HOUSTON AIRPORT SYSTEM

**SUBJECT:** Addendum No. 5

**REFERENCE:** Invitation To Bid (ITB) for the IAH Integrated Coordination Center at George Bush Intercontinental Airport; Solicitation No. H06-IAHICC-2024-004; Project No. 793

10.2

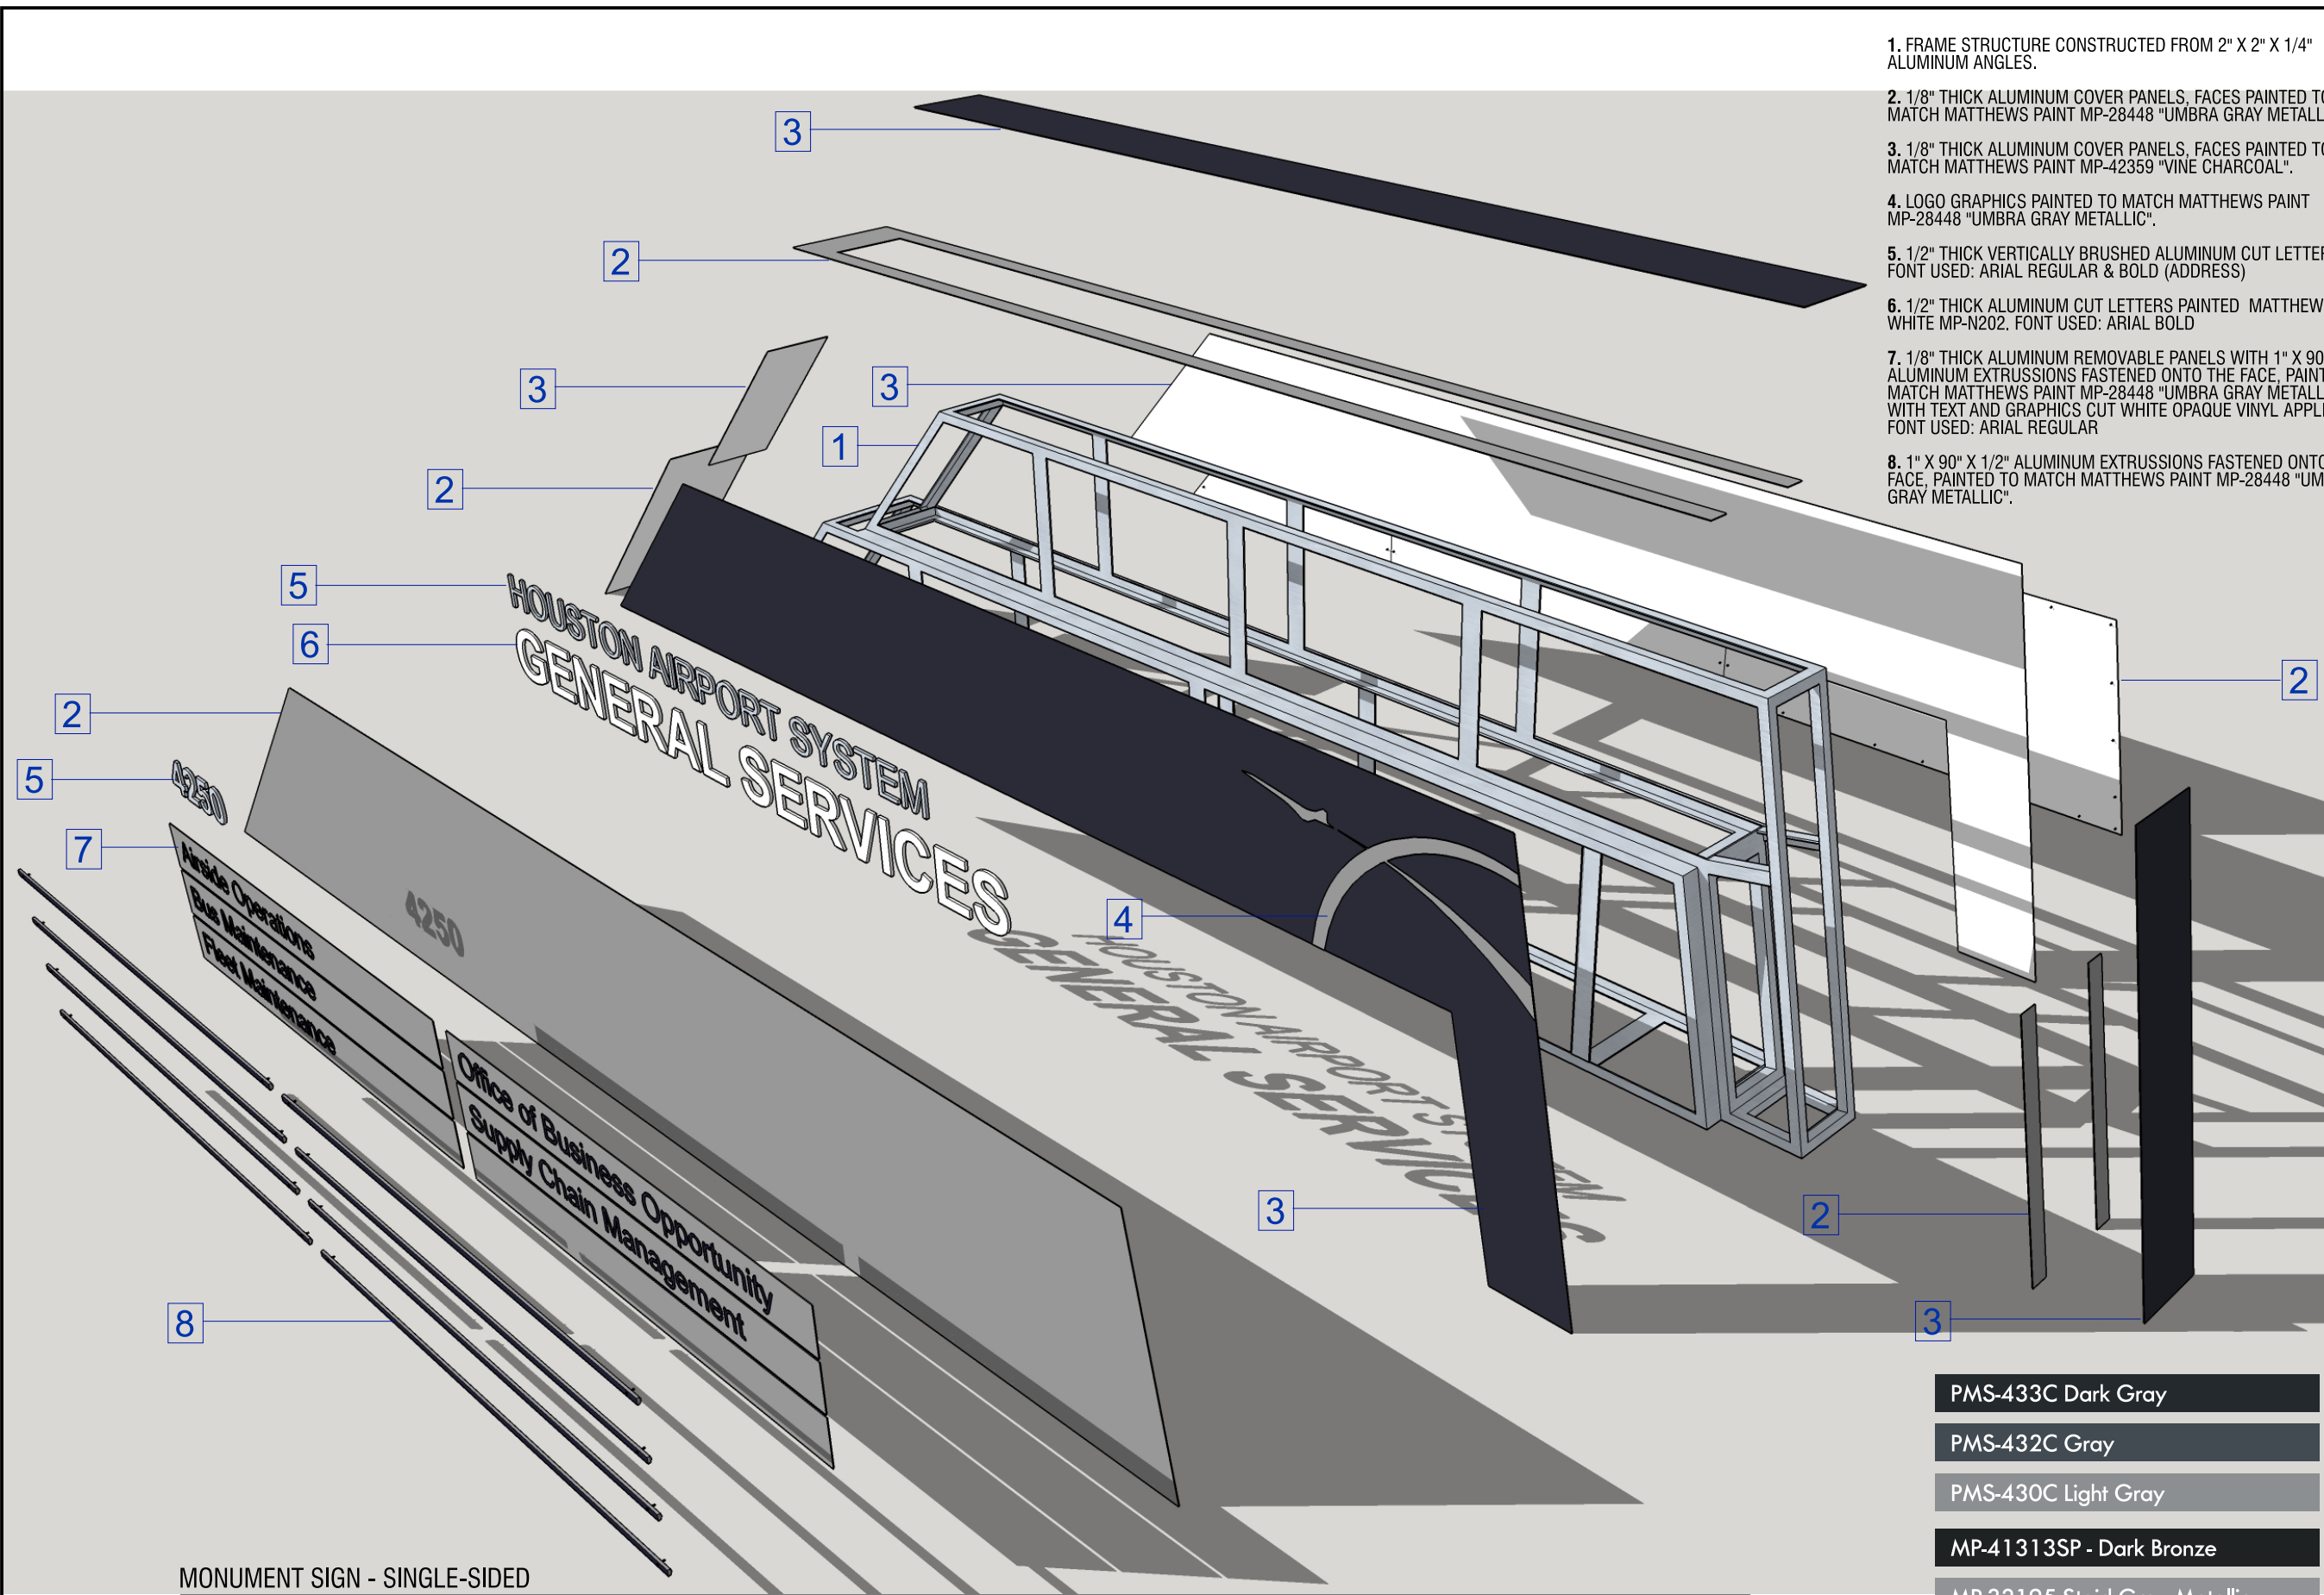
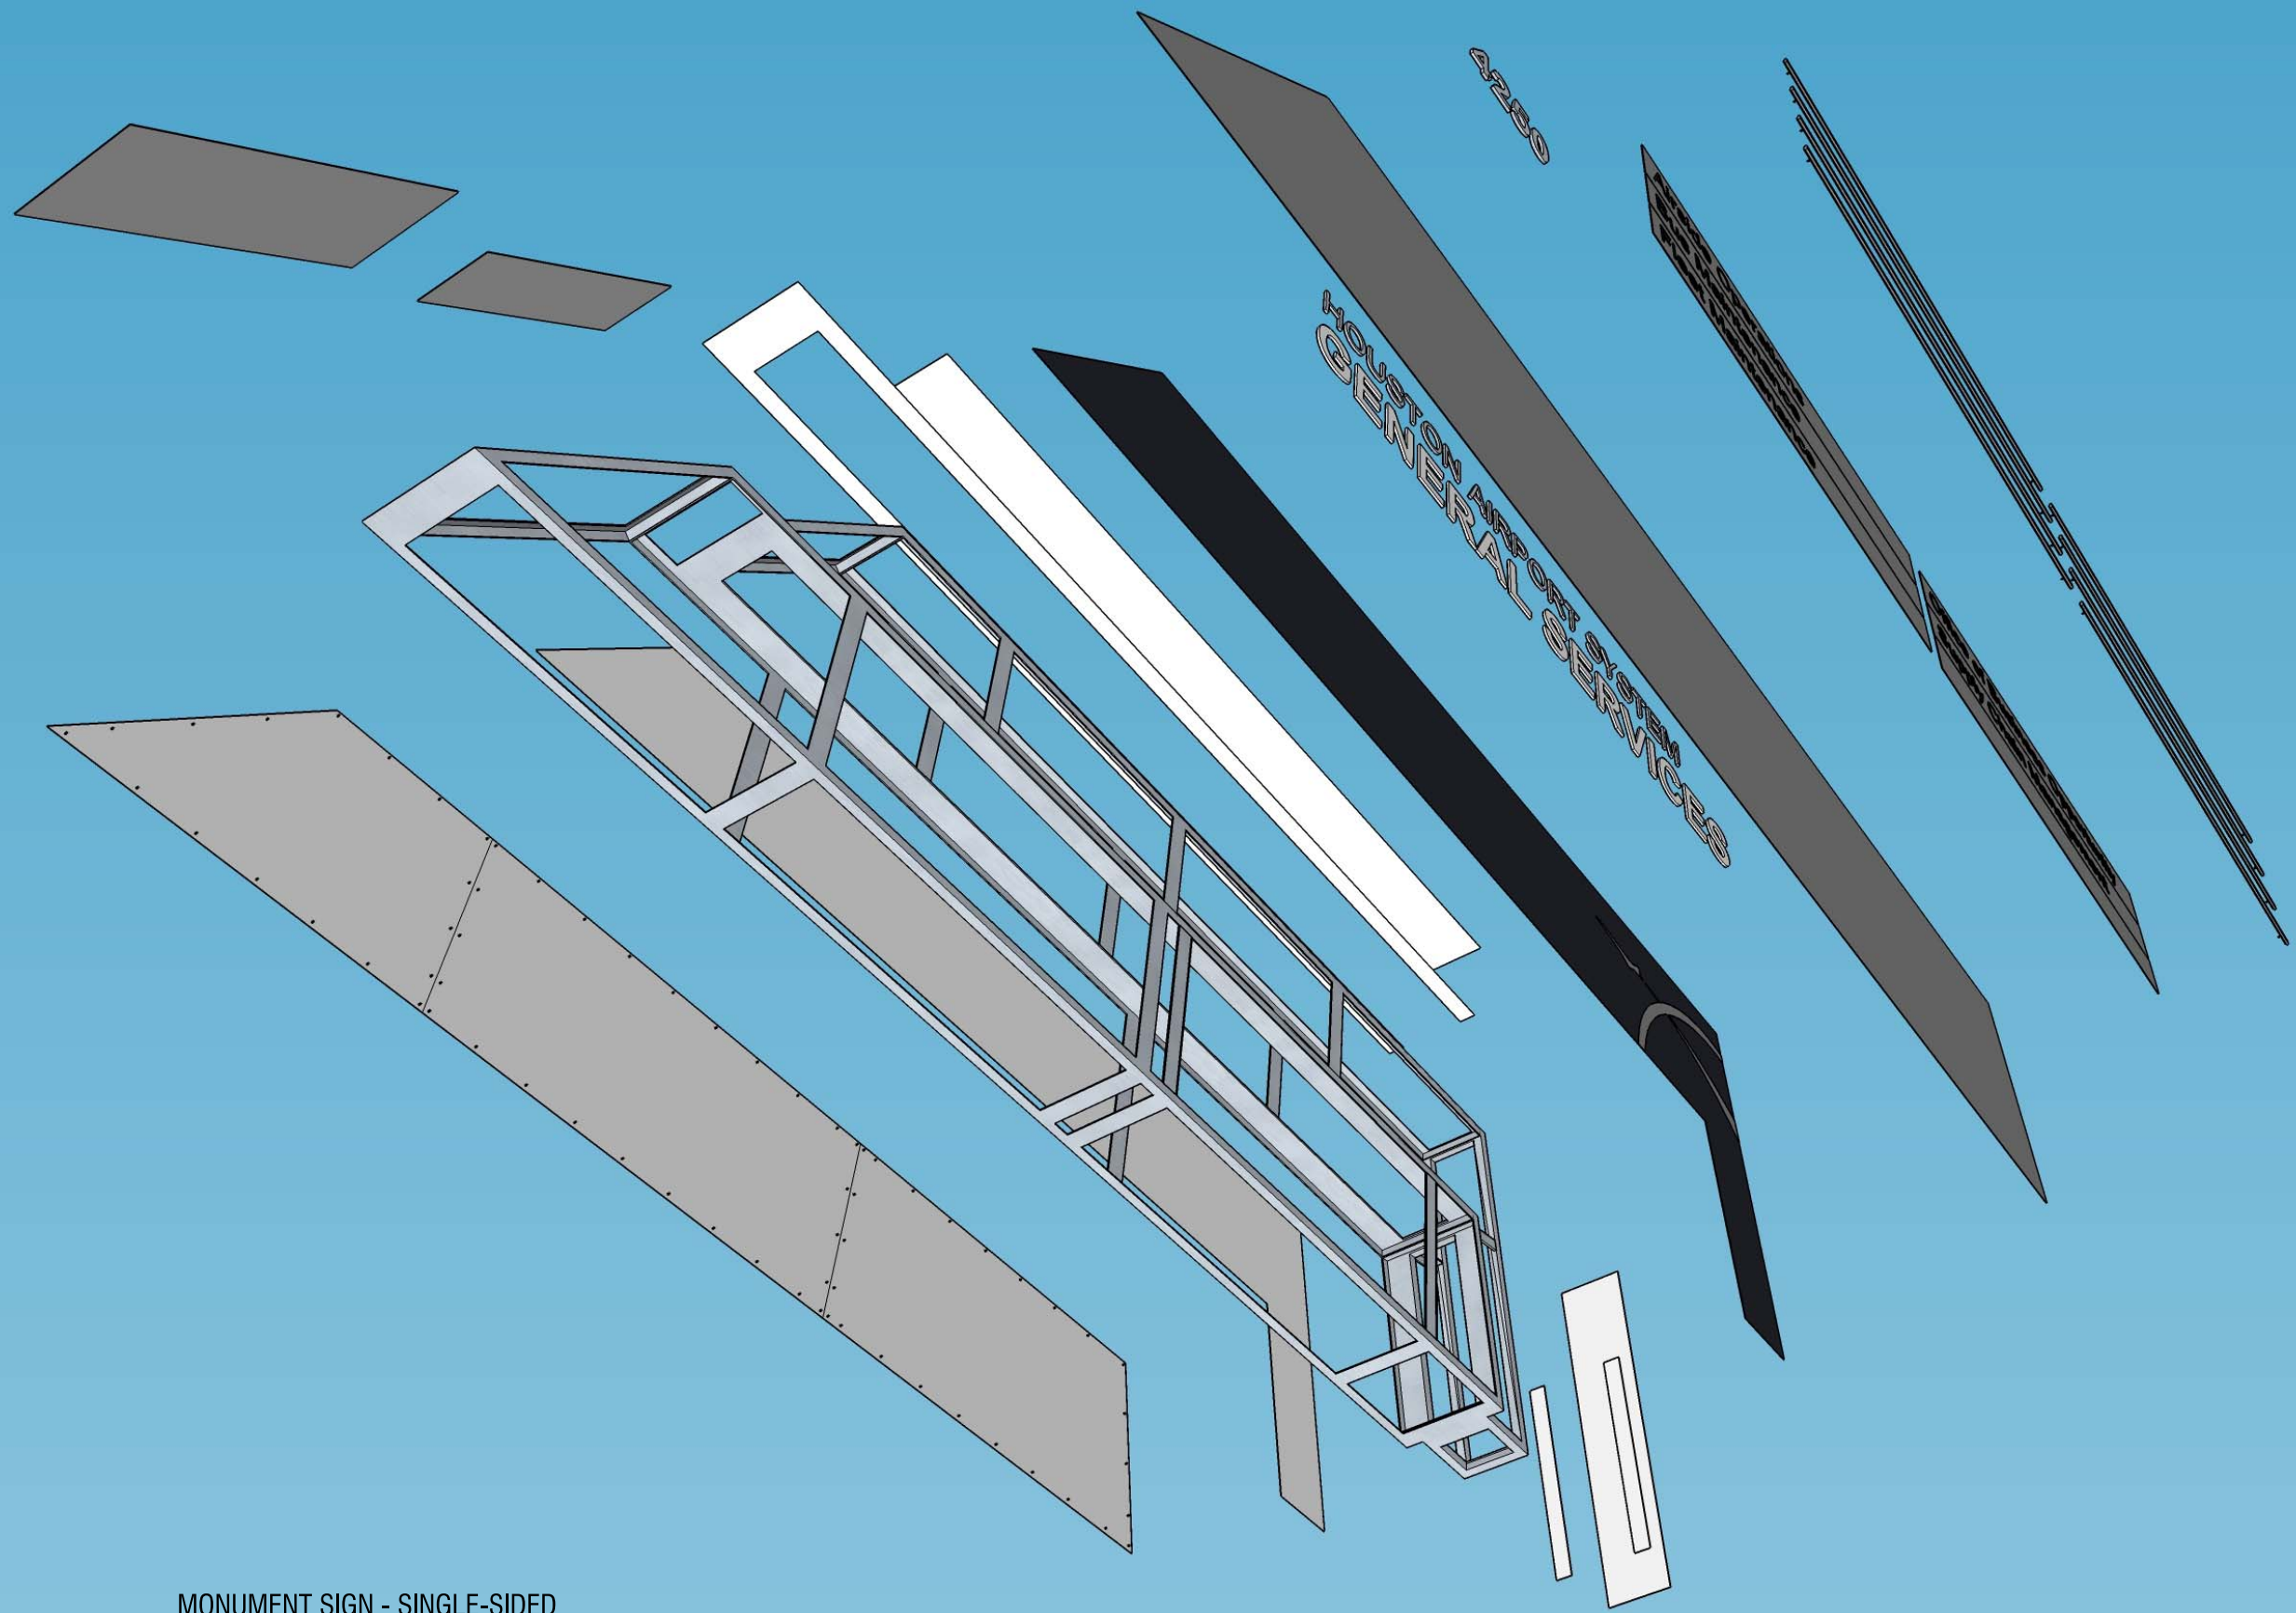
2. **Question:** On page A612 you have to replace letters on the monument wall with others that match. I need to know:
  - a. The height of the other letters
  - b. The depth
  - c. The font
  - d. The color
  - e. The material
  - f. Are they fabricated by routing or are they channel?

g. Do they light up at night?

**Response:** Please see Sheet 10, Sheet 10.1, Sheet 10.2, and Sheet 10.3 attached to this Addendum.

1. FRAME STRUCTURE CONSTRUCTED FROM 2" X 2" X 1/4" ALUMINUM ANGLES.

2. 1/8" THICK ALUMINUM COVER PANELS, FACES PAINTED TO MATCH MATTHEWS PAINT MP-28448 "UMBRA GRAY METALLIC".

3. 1/8" THICK ALUMINUM COVER PANELS, FACES PAINTED TO MATCH MATTHEWS PAINT MP-42359 "VINE CHARCOAL".

5. 1/2" THICK VERTICALLY BRUSHED ALUMINUM CUT LETTERS. FONT USED: ARIAL REGULAR & BOLD (ADDRESS)

6. 1/2" THICK ALUMINUM CUT LETTERS PAINTED MATTHEWS WHITE MP-N202. FONT USED: ARIAL BOLD
